## **ADDENDUM NO. 01**

February 6, 2017

Project: Camp Murray Beach Sewer Maintenance & Historical Dist. Sewer Repairs Washington Military Department, State Project #2016-644/645

C1.1A

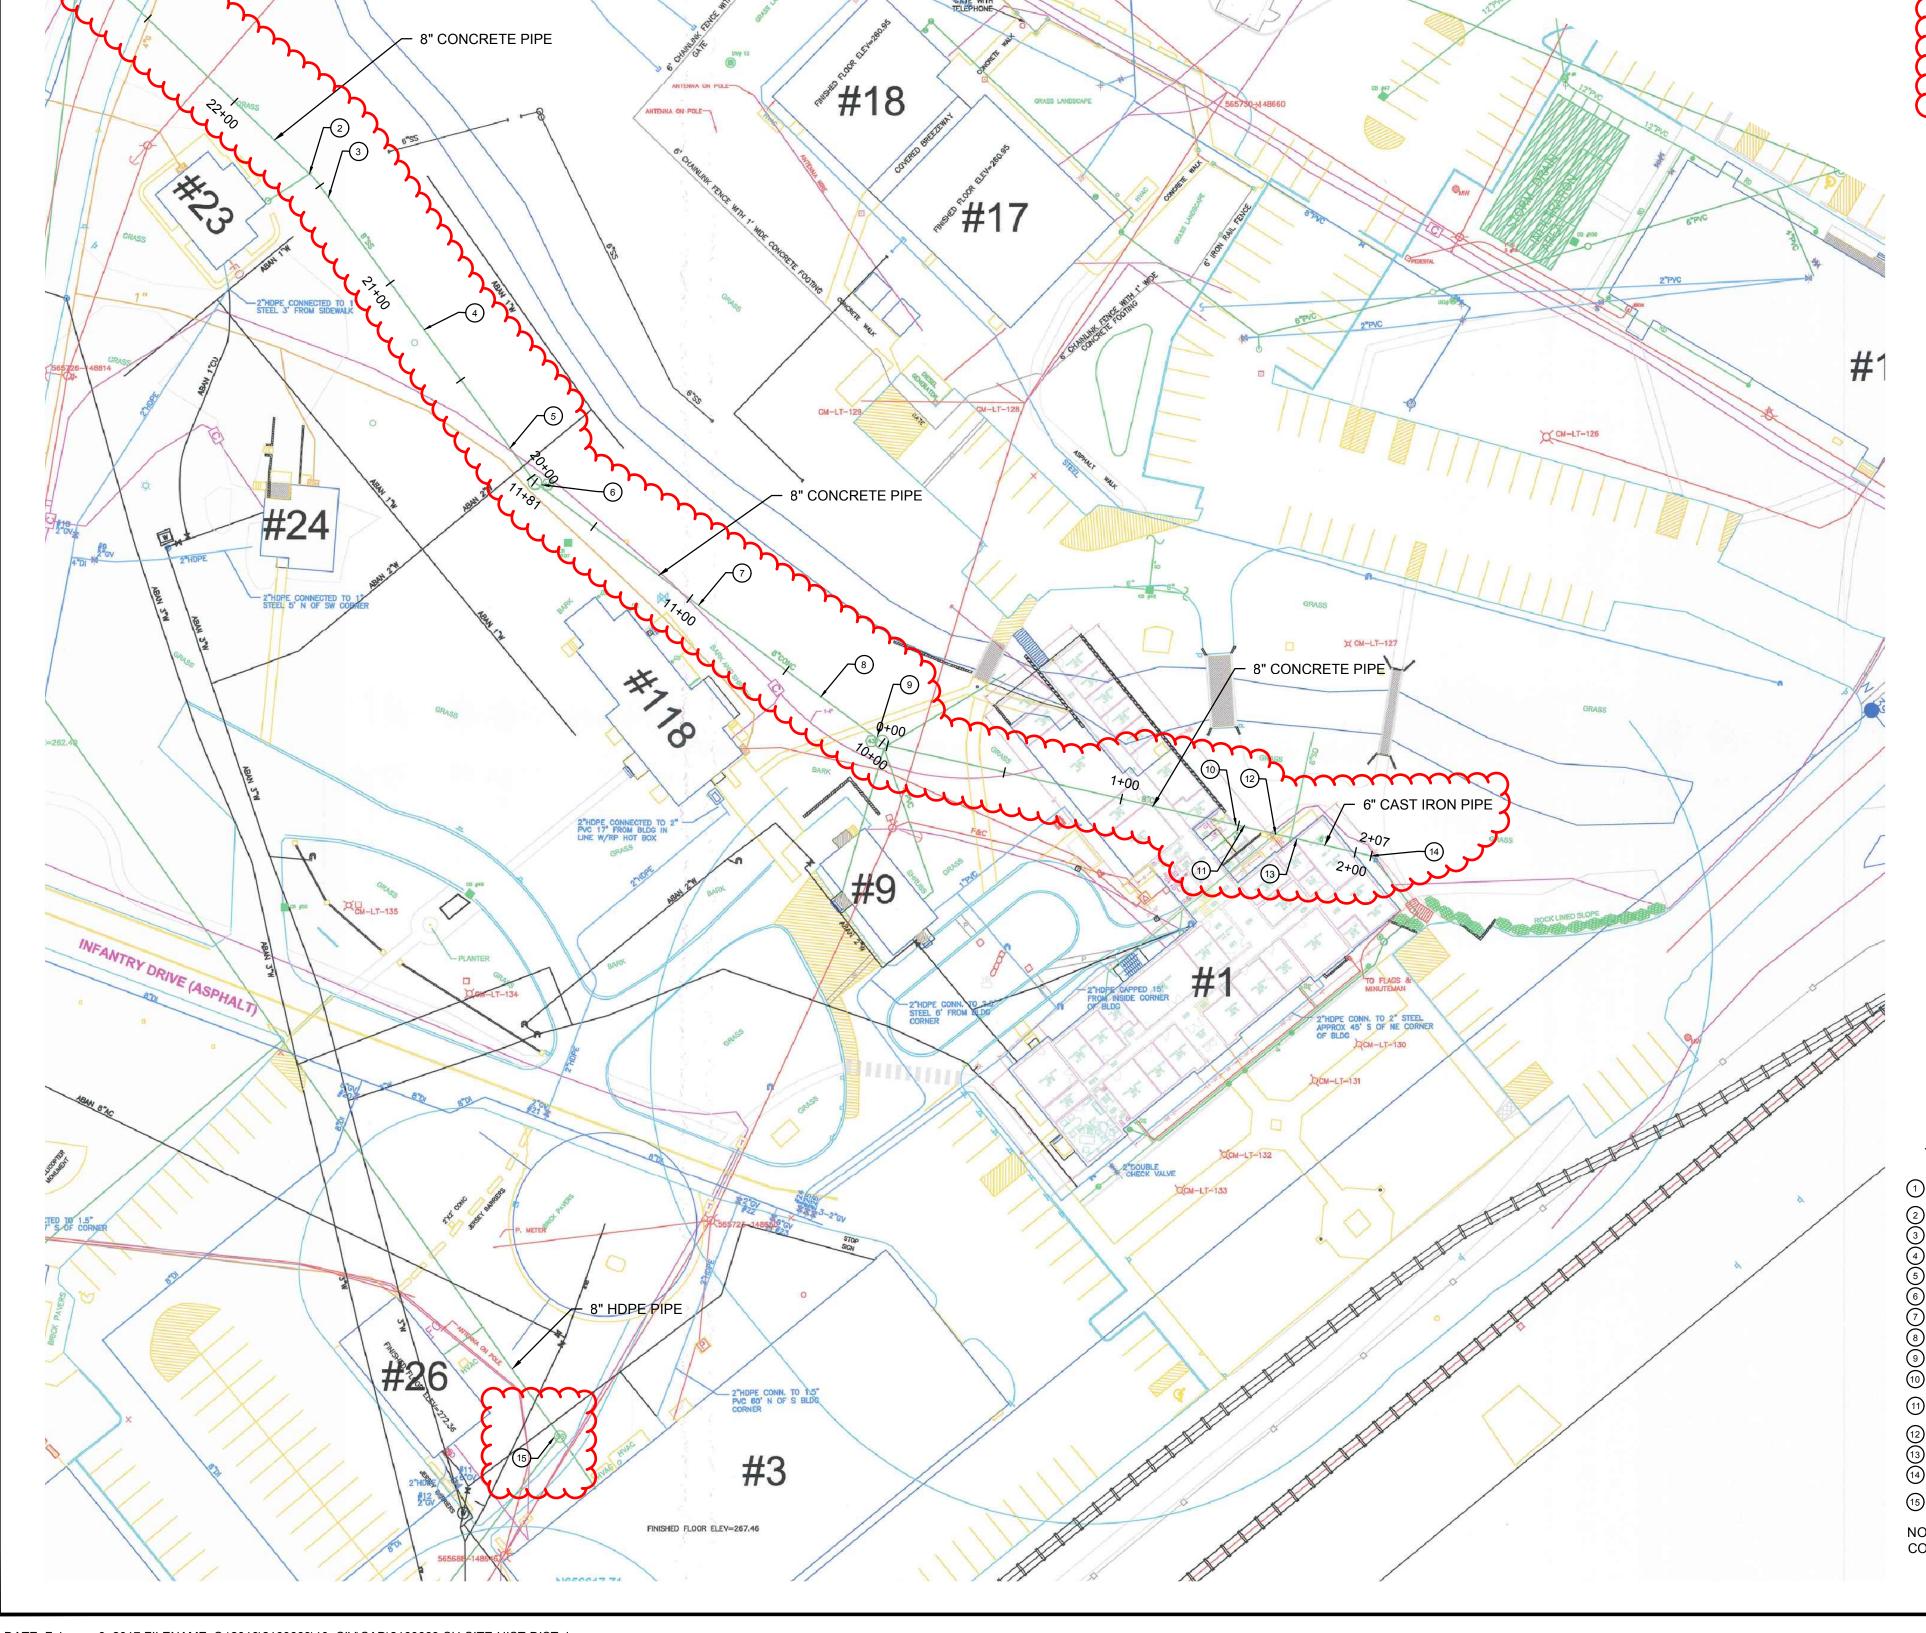
ADD #01 **REPLACE** sheet C1.1 with sheets C1.1A and C1.1B

PROVIDE CURED-IN-PLACE PIPE (CIPP) SYSTEM ALONG APPROXIMATELY 680LF OF EXISTING
DETERIORATING 6-INCH AND 8-INCH PIPE AS IDENTIFIED ON THIS SHEET. REHABILITATE 1 BRICK MANHOLE
WITH CEMENTITIOUS MORTAR LINING (CML). REHABILITATE 1 CONCRETE MANHOLE TO MAKE WATER-TIGHT.
